CASTLEGAR & DISTRICT RECREATION COMPLEX R6-R7 ROOF REPLACEMENT PRJ #25034

ADDENDUM NO. 3

Issued: March 17, 2026

DATE:	DESIGNED:	DRAWN:
2024.12.20	AM	NM
SCALE:		SHEET NO.
3/32"=1'-0"		A1.02
APPROVED BY:	DEREK BUDDÉ P.ENG

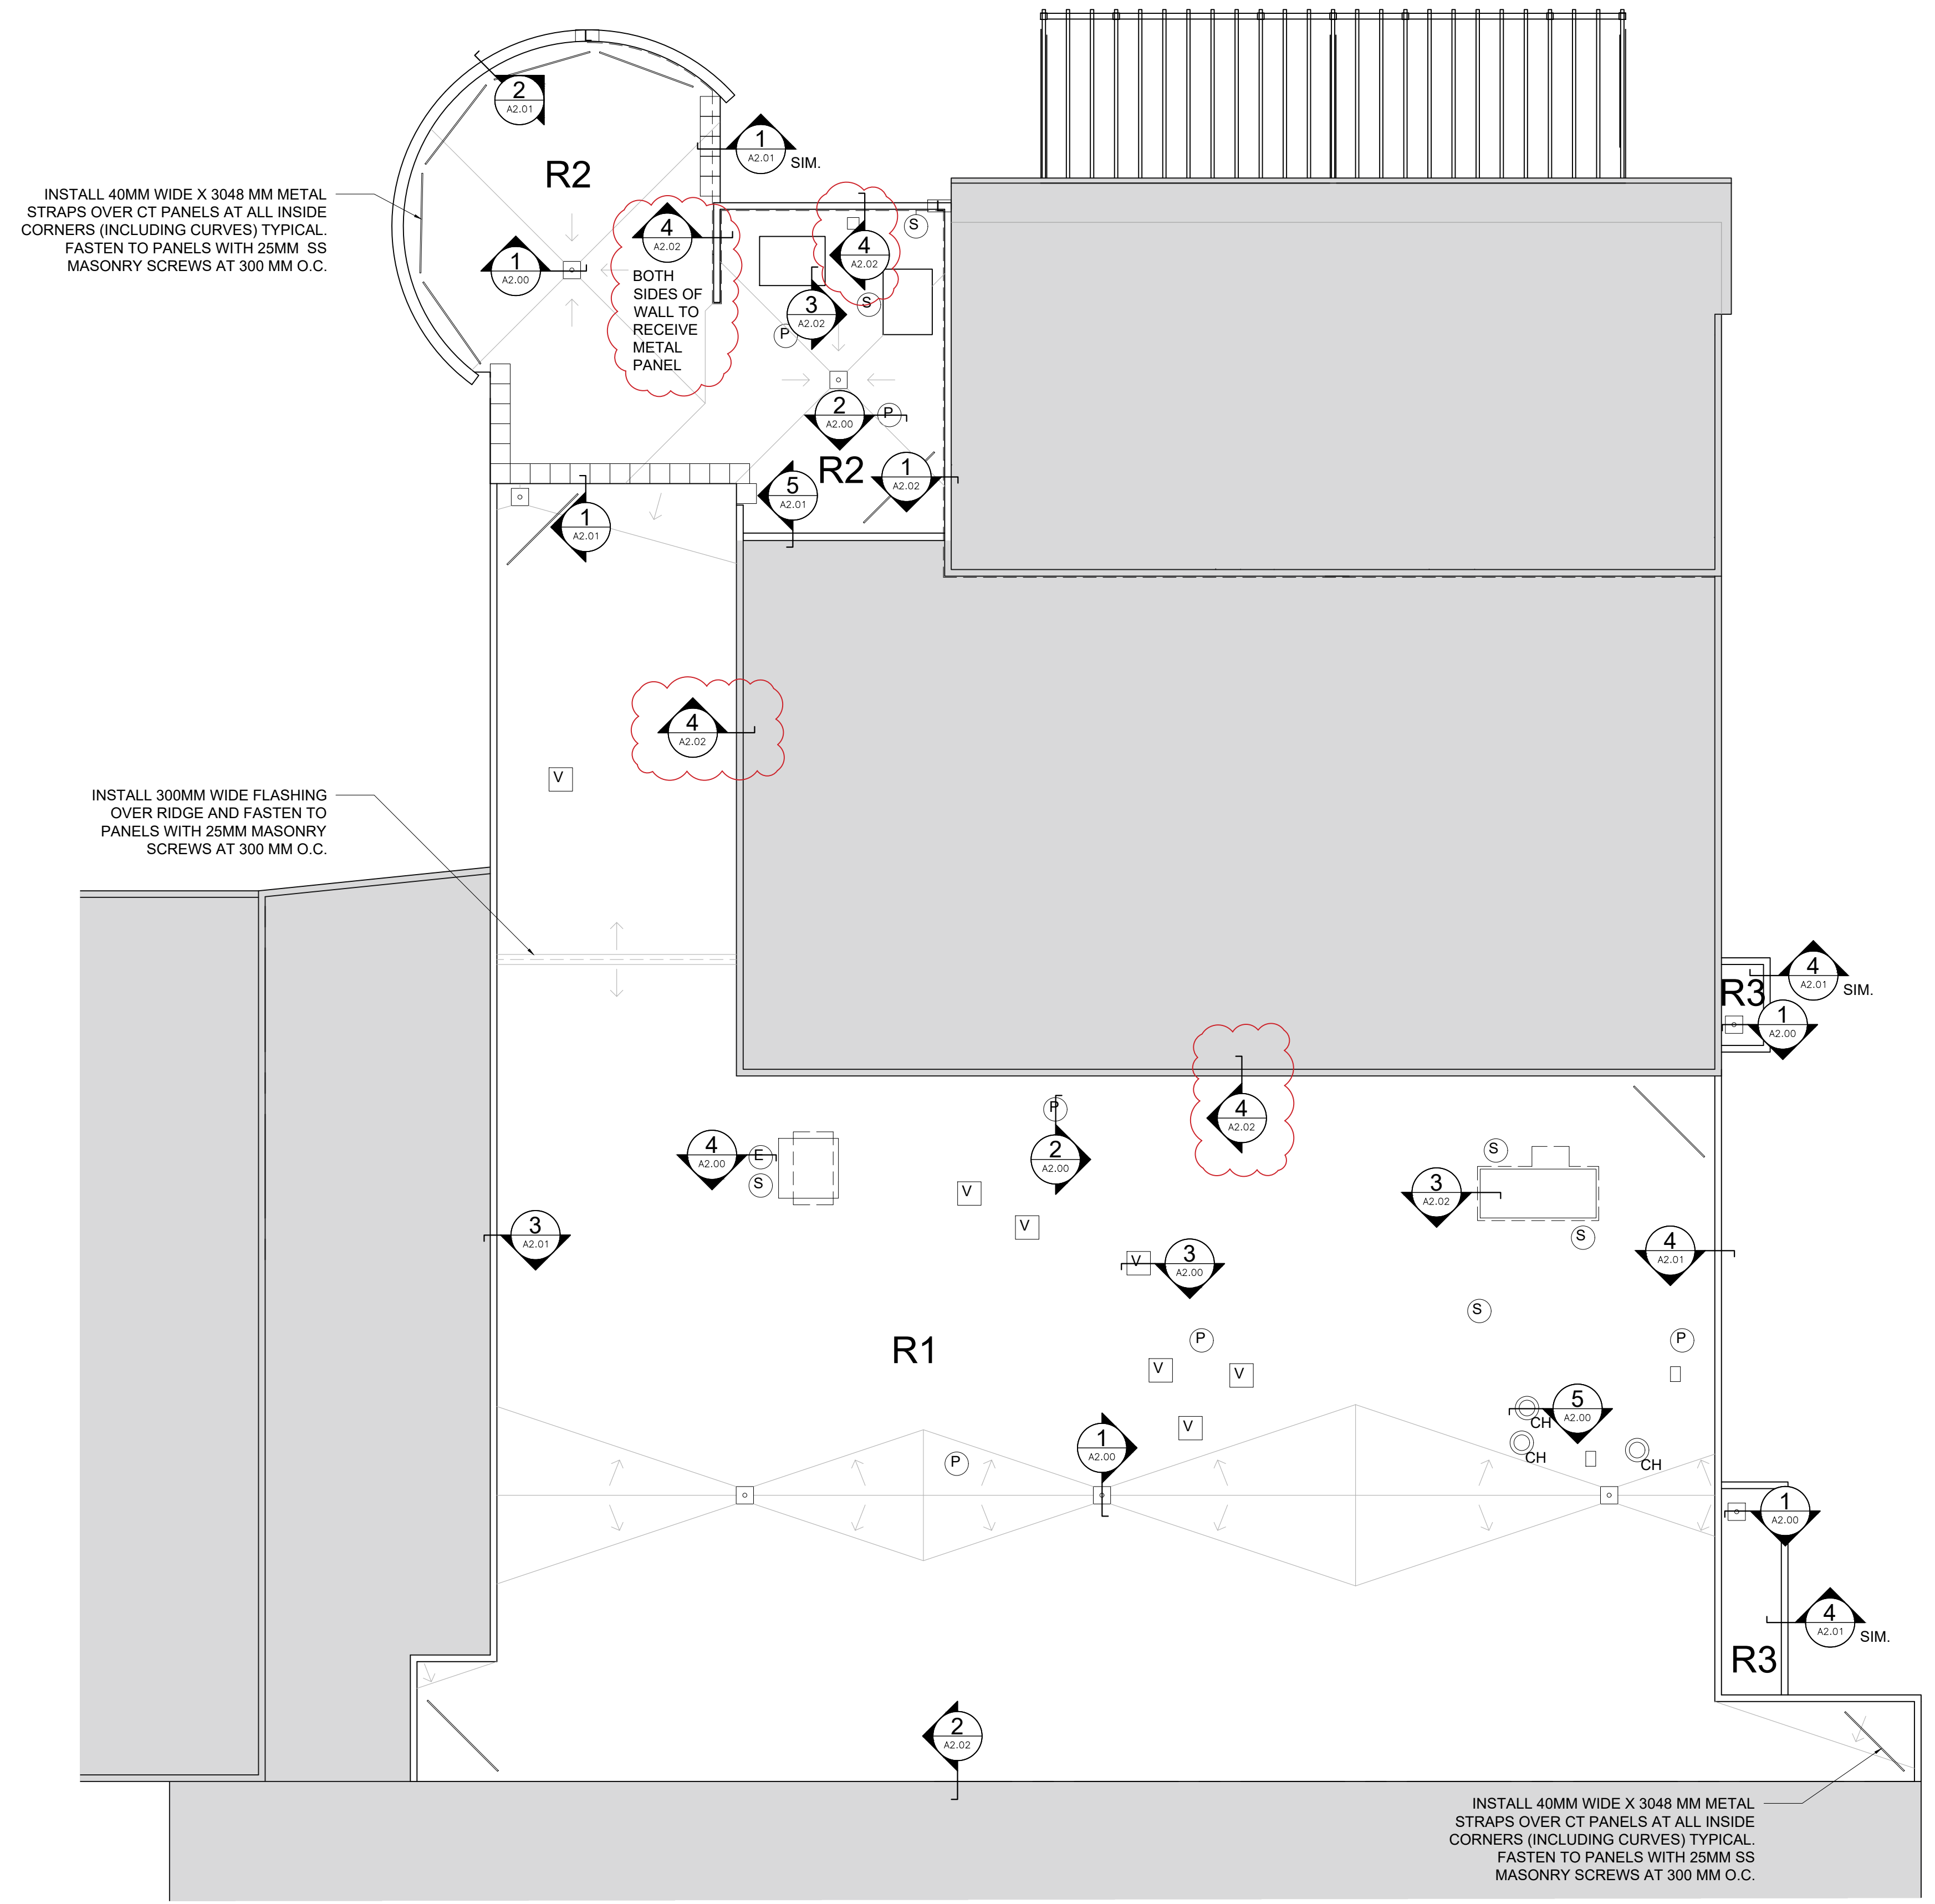
See attached revised drawing A1.02 and A2.02 showing cladding detail on CMU walls.
